Final Drainage Report

Security Fire Station No. 4

Project No. 61134

February, 2021

DEVELOPED DRAINAGE CONDITIONS (MAP POCKET)

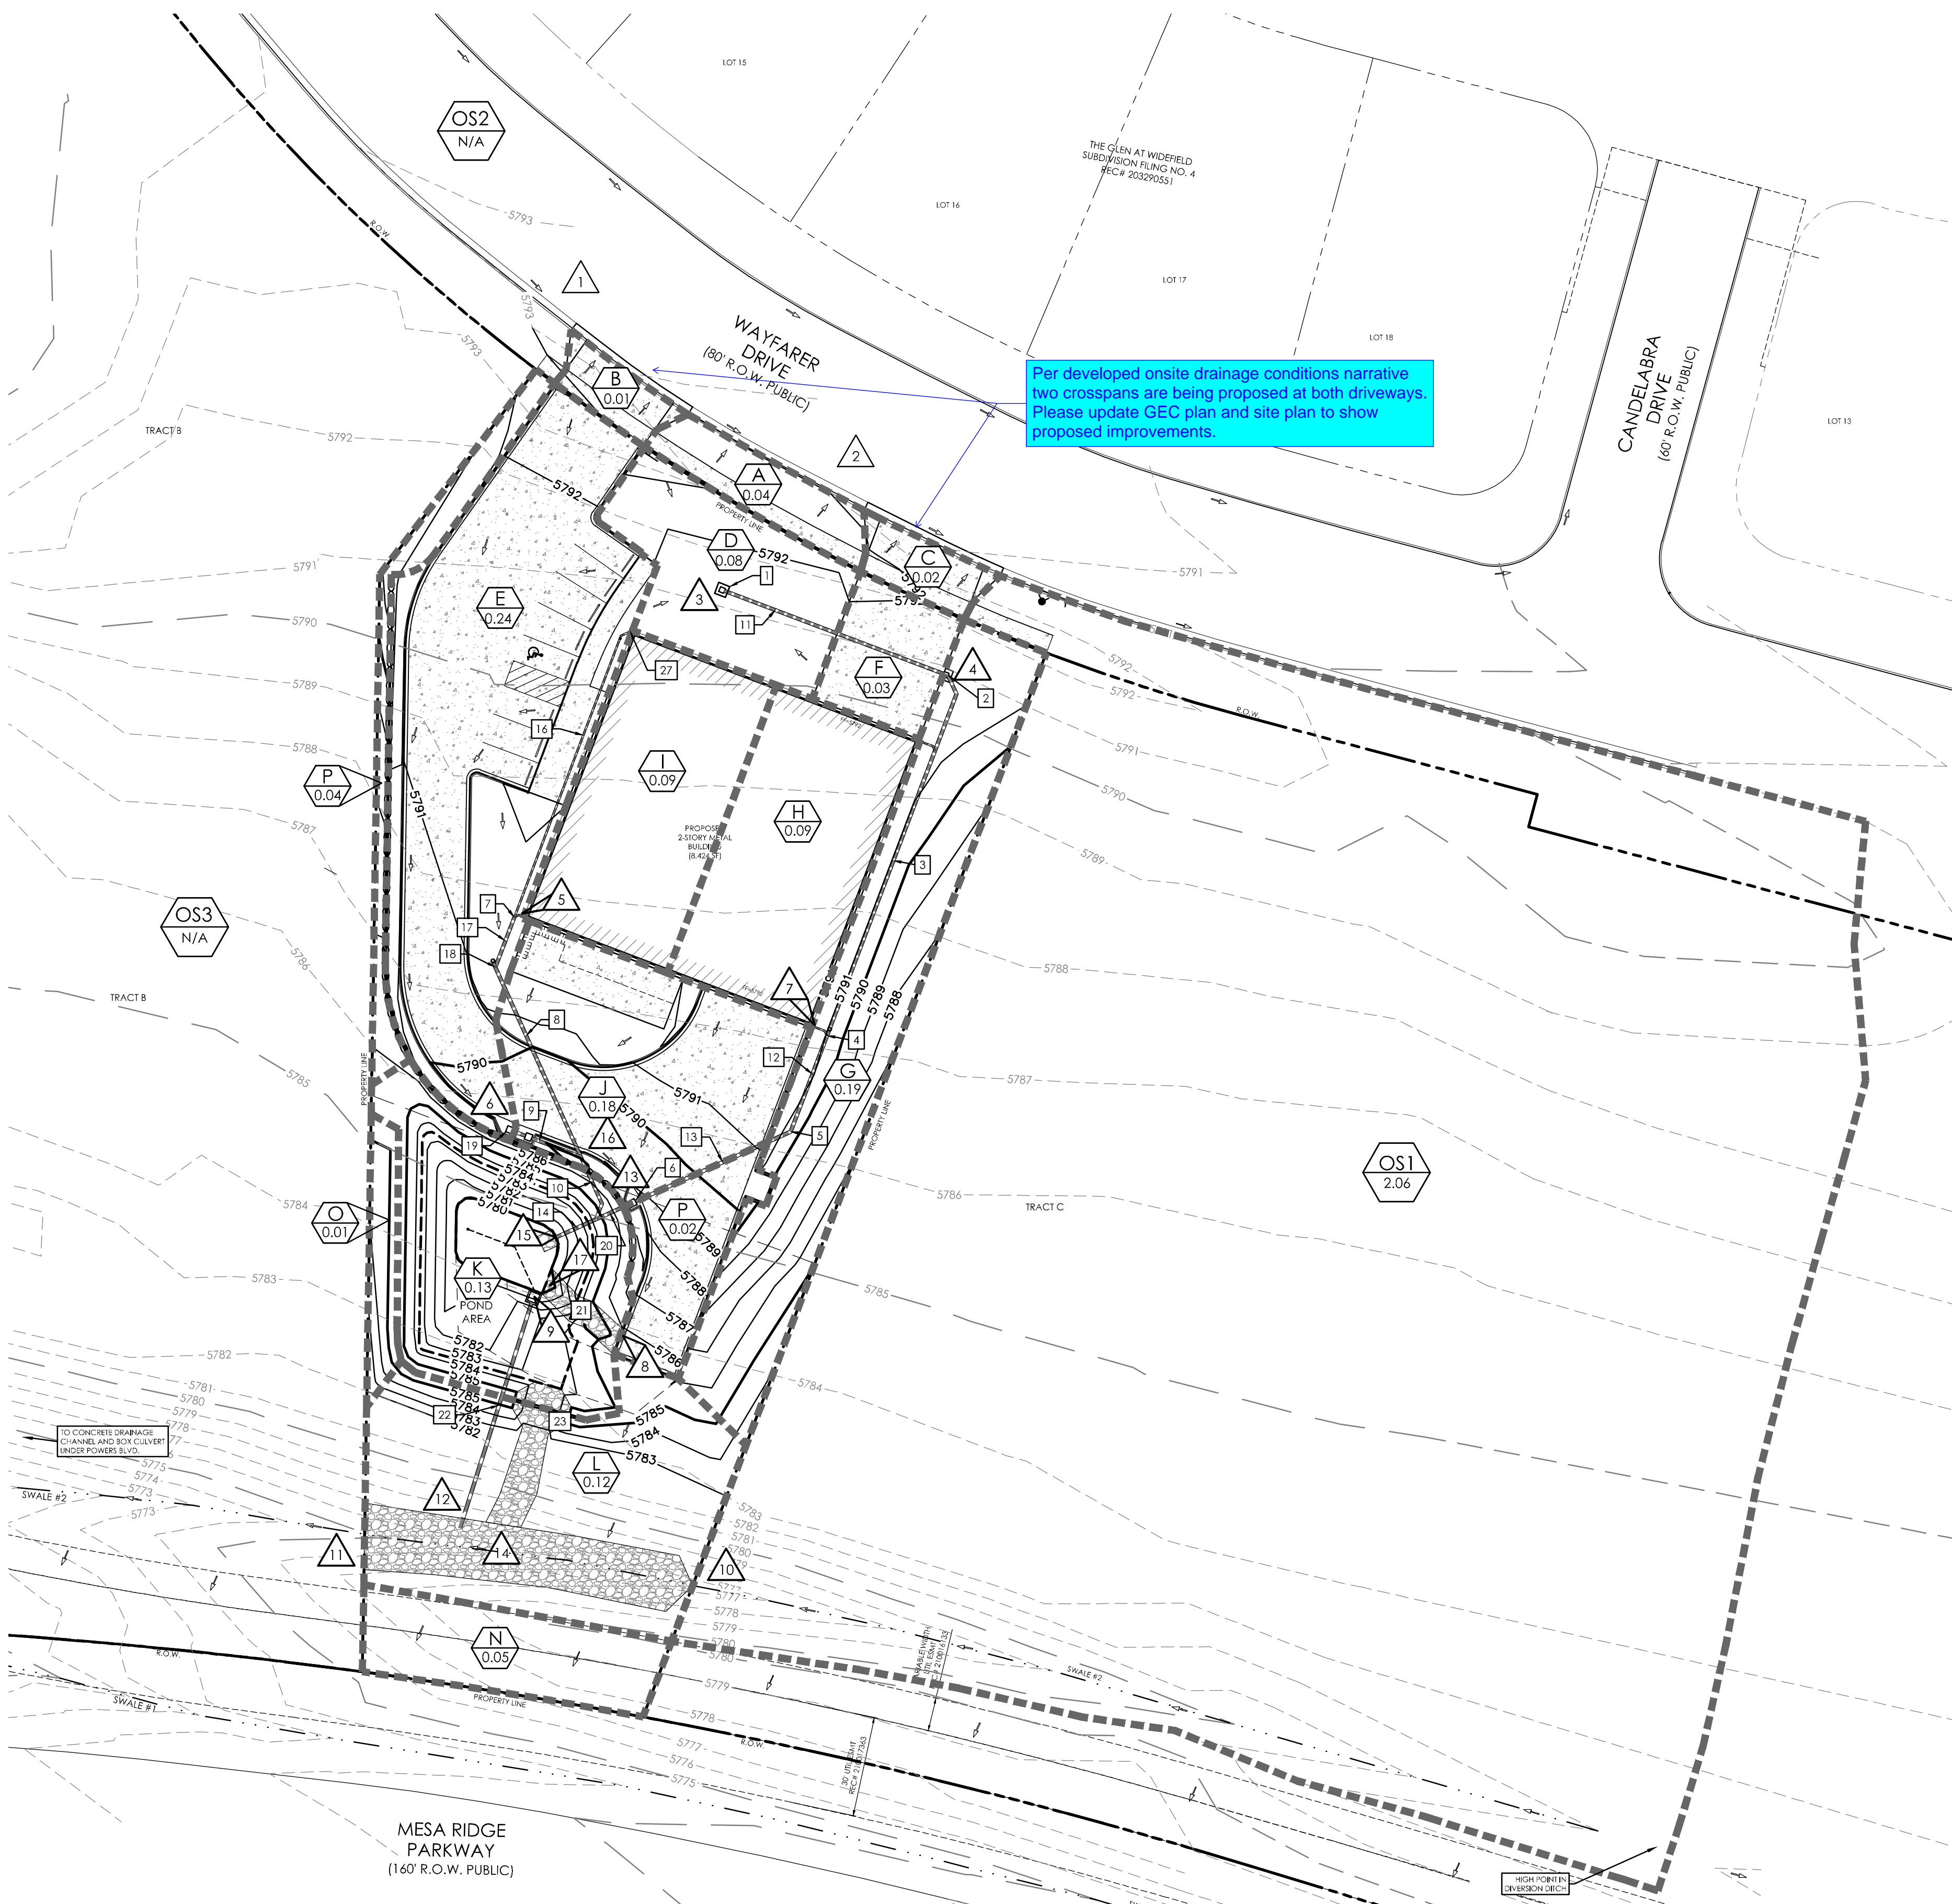
Please update drainage map contents to include property boundaries and drainage easements within site.
